Product Change Notification / KSRA-15BCAH919

CCB 4437 Final Notice: Implement MMT shipping tube for selected AT27xxxx, AT28xxxx and SST39xxxx products available in 32L PLCC package.

**KSRA-15BCAH919
CCB 4437**

Shipping Tube Pre and Post Change

☐ Tube Comparison (AT27xxxx and AT28xxxx Products):

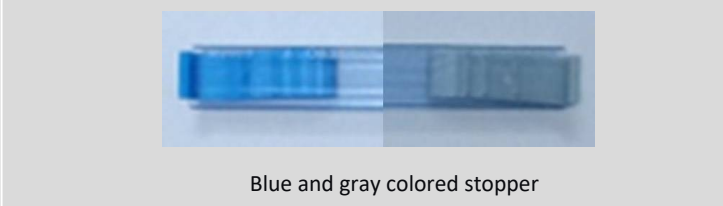
| Pre change | Post change |
|---|--|
| <p>Length: 20.40+/-0.10 inch Width: 0.600+0.015/-0.005 inch Tube Opening Length (A): 0.174 + 0.010 inch Tube Opening Width (B): 0.530+0.010/-0.000 inch Wall thickness (T): 0.035 + 0.005 Tube Opening:</p>  | <p>Length: 21.70 ± 0.045 inch Width: 0.560 ± 0.015 inch Tube Opening Length (A): 0.170 ± 0.010 inch Tube Opening Width (B): 0.510 ± 0.010 inch Wall thickness (T): 0.025 ± 0.005 inch Tube Opening:</p>  |

For AT27xxxx and AT28xxxx Products

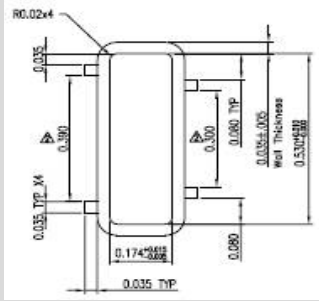
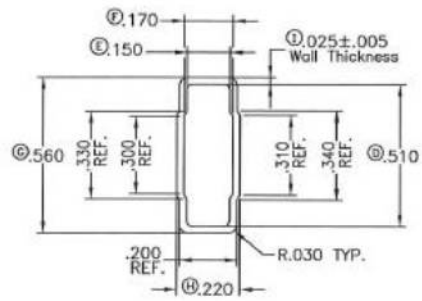
Tube Stopper
